# **SITE DEVELOPMENT REVIEW COMMITTEE COMMENTS No. # 1**

Project: SCHIEFFER BUSINESS PARK – SP24-20

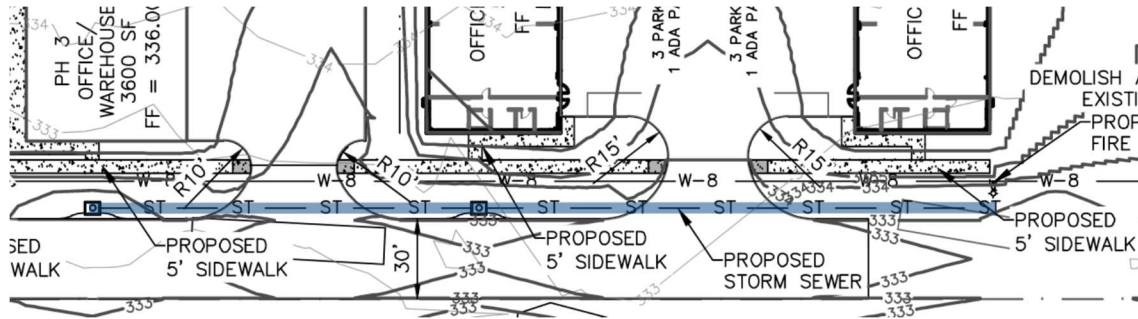
4. The proposed site improvements appear to include storm sewer (as shown in the clipping below). Please elaborate on the proposed outfall and if any detention facilities are proposed. FYI: If discharging to E SH 21, TXDOT permits will be required.

*The detention pond will be located within the county portion.*
